Delegated Report

Householder Planning Application

Planning Application No: 20230001

Description: Proposed single storey rear extension, two storey rear extension and porch and two storey side extension with altered fenestration

Single storey rear and first floor side extension approved under ref 20200406 (Not to Scale)

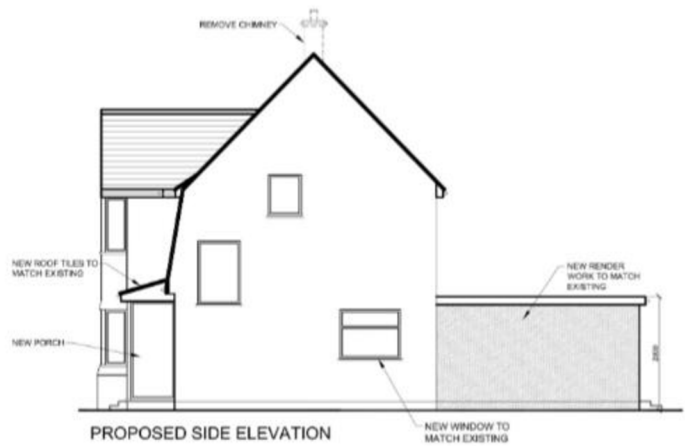
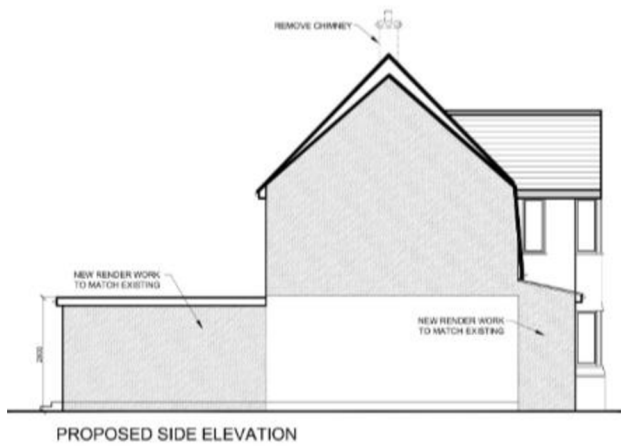
The impact of the proposed side extension on the streetscene, in particular the harm resulting from reduced visual spacing at first floor level has been previously addressed in the delegated reports ref 20190971 and 20200406. In the latter the officer stated:

'The first-floor side extension would fill in the current space to the side of the application property, which can be harmful due to the creation of a 'terracing' effect. However, on this road there are differing house styles with generally little space between the properties. The front gardens largely provide a set back and sense of space around the buildings on the road. There is a bungalow adjacent to the eastern flank boundary of the application site, and whilst at first floor level the existing house would come closer to this boundary, there would be no terracing effect created by the proposal, and as the roof over the bungalow pitches away from the boundary there will still be a sense of space to the side of the application property.'

I agree with this assessment in the sense that the loss of the visual spacing is not a positive design feature of this proposal. However, given the existing character of this reduced spacing in the wider area, it would not result in significant harm to the character of the locality, where such features usually exist. It would therefore be inappropriate to object to the principle of the side extension merely based on the reduced visual spacing. It should, however, be subservient in appearance and of good design appropriate to the area. This proposed extension is like the previous approval in scale and appearance. It would be set down from the ridge and as a development feature considered alone, would be subservient in appearance. However the side extension links to a two storey rear extension which is expanded upon below.

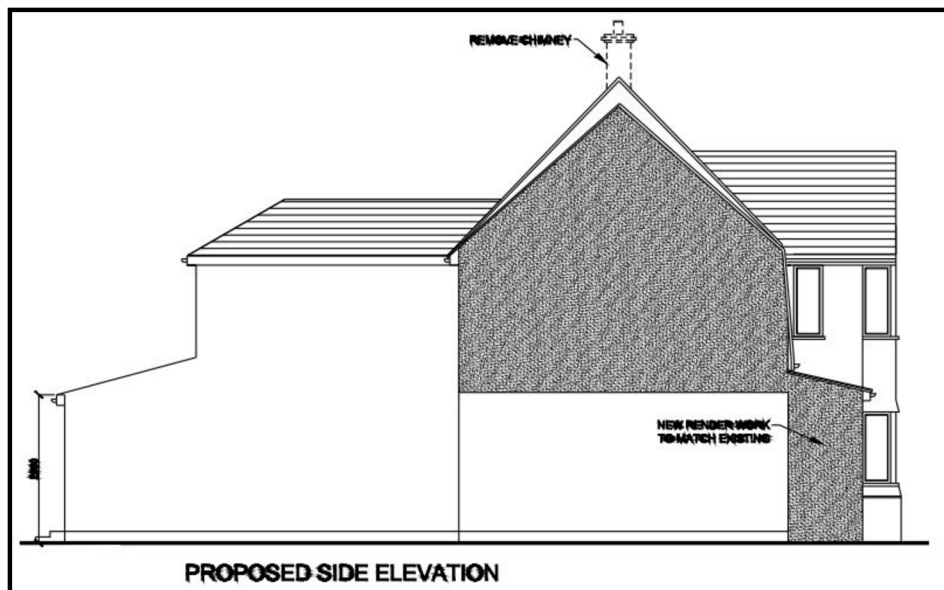
The existing dwellinghouse is a three-bedroom property. The proposed extension would result in four

bedrooms. A kitchen/diner, lounge, garage, office, lobby and WC at ground floor and four bedrooms, two ensembles, a bathroom and hallway to the first floor.

The rooms are expected meet the required minimum space standards and continue to have adequate rear garden depth and area as per SPG2 - Residential layout guidelines including Housing Standards Policy Statement October 2015 Adopted 1996 – amended June 2020.

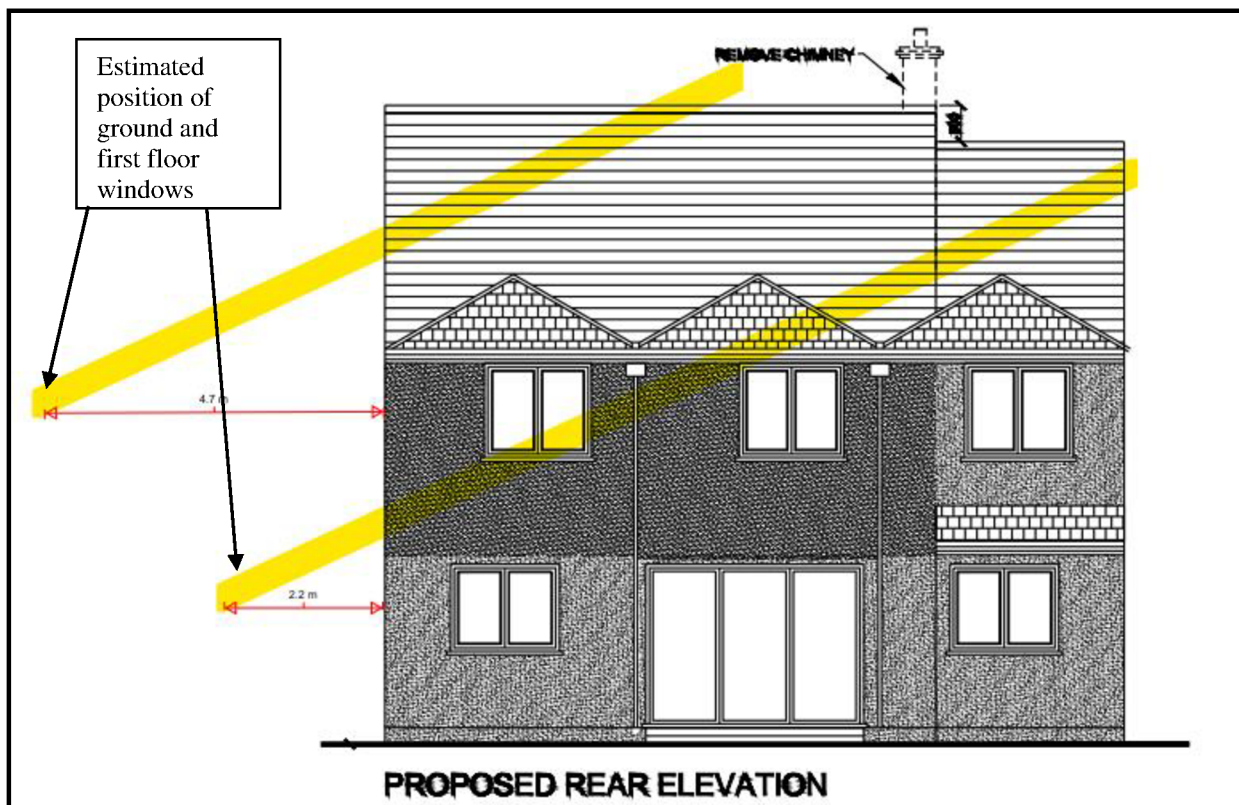
As the below images show, there are a number of openings on the side elevation of the neighbour's property with potential to be overshadowed as a result of the two-storey rear extension:

The highlighted yellow line in the above image shows the likely areas of overshadowing from the new development, using a 25-degree test. The first-floor window would likely not be significantly overshadowed, but the ground floor window would. However, as the below elevation taken from the neighbours planning application ref 20010469 shows, there is another window serving this room to the rear, which given that the proposed extension would not front this window, would not be overshadowed.
